SUBJECT: Forwards addl info re spent fuel pool cooling sys, per 851205 meeting & 860108 ltr. Spent fuel pool cooling sys complies w/licensing criteria & meets intent of GDC44 of 10CFR50, App A.

PGandE Letter No.: DCL-86-020

Re: Docket No. 50-275, OL-DPR-80  
Docket No. 50-323, OL-DPR-82  
Diablo Canyon Units 1 and 2  
Supplement to the Spent Fuel Pool Reracking Report

DIABLO CANYON UNITS 1 AND 2  
SPENT FUEL POOL COOLING SYSTEM

Figure 1

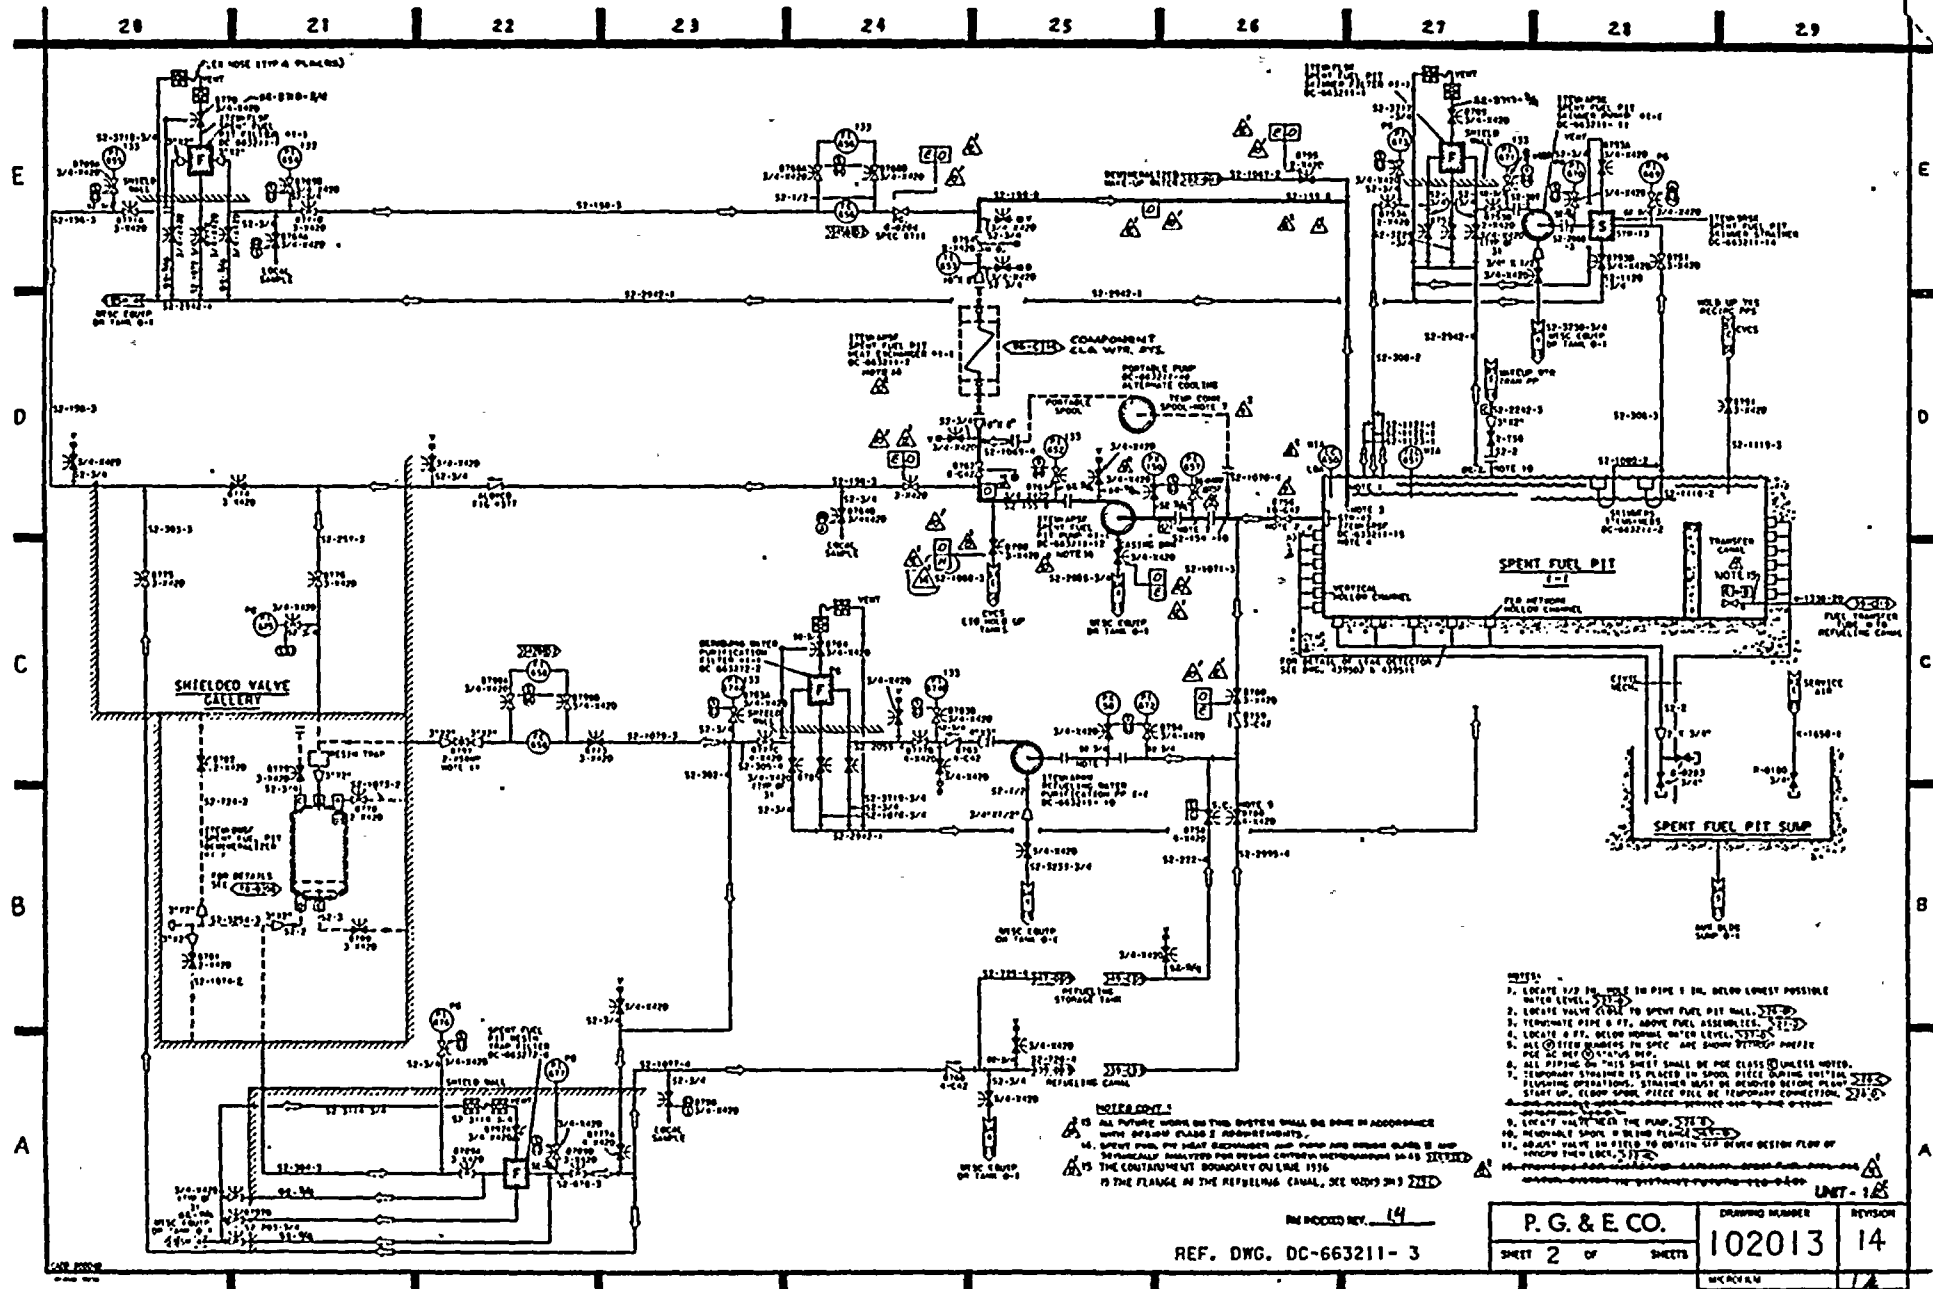
Discuss the spent fuel pool cooling system with respect to the requirements of General Design Criterion 44 of 10 CFR 50, Appendix A.

To facilitate pump maintenance and improve operational flexibility, a second 100% capacity pump for each spent fuel pool, powered from a vital power supply, will be installed as discussed later in this enclosure. The following is a detailed description of the current spent fuel pool cooling system (Figure 1 is a piping schematic of the existing spent fuel pool cooling and cleanup system).

The cooling system water is pumped from the pool through the tube side of the heat exchanger and returned to the pool. The pump suction line is protected by a strainer and is located at an elevation 4 feet below the normal spent fuel pool water level. The return line contains an antisiphon hole near the surface of the water to prevent gravity drainage of the pool. System piping is arranged so that failure of any pipeline cannot drain the spent fuel pool below the water level required for radiation shielding.

The spent fuel pool pump is a horizontal, centrifugal unit. The pump has a design flow of 2,300 gpm and is controlled manually from a local station. The spent fuel pool heat exchanger is of the shell and U-tube type with the tubes welded to the tube sheet. During the normal operation, component cooling water circulates through the shell side at a higher pressure than the tube

Manual stop valves are used to isolate equipment and manual throttle valves provide flow control. All piping and valves in contact with spent fuel pool water are austenitic stainless steel. The piping is welded except where flanged connections are used to facilitate maintenance.

The existing spent fuel pool cooling system is highly reliable and designed to Seismic Design Class I criteria. Electrical power is Class IE and the system is located in a mild environment. It is a low-pressure system with borated demineralized water and is capable of providing cooling for both normal and abnormal conditions. In the unlikely event that the spent fuel pool pump should fail for an extended period, a Design Class II portable pump with a flowrate of approximately 700 gpm and permanent connections in the spent fuel pool cooling loop are provided as a backup to the permanently installed pump.

As discussed earlier, PGandE will install a permanent second 100% capacity spent fuel pool cooling pump for each unit prior to exceeding the spent fuel storage limit identified in the FSAR Update (i.e., 270 fuel assemblies). Provisions for the existing portable pump will be eliminated at that time. To minimize the impact on operation of the existing cooling system when installing these pumps, and to help maintain radiation exposures as low as is reasonably achievable during installation, the piping connections for the second 100% capacity pump to the existing cooling loop will be installed prior to the first refueling outage of each unit. These new Design Class I pumps will be seismically qualified and provided with Class 1E power.
